NUREG-XXXX, Vol. 3

**Safety Evaluation Report  
Related to Disposal of  
High-Level Radioactive  
Wastes in a Geologic  
Repository at Yucca  
Mountain, Nevada**

Volume 3: Repository Safety After  
Permanent Closure

Figure 6-1. Potential Flow Pathways in the EBS  
(SAR Figure 2.3.7-8; DOE, 2008ab)

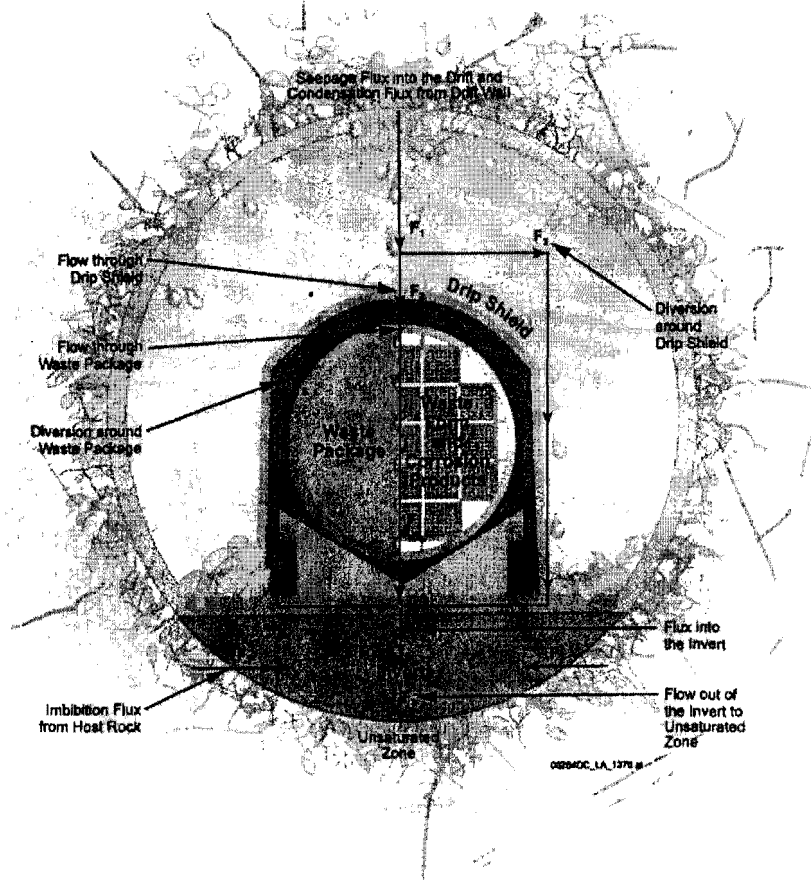
(b)(5) However, as shown in Figure 6-1, this diverted flux around the failed waste package enters into the invert and is used to calculate F6, which determines the advective transport of radionuclides and colloids in the invert domain of the EBS radionuclide transport abstraction.
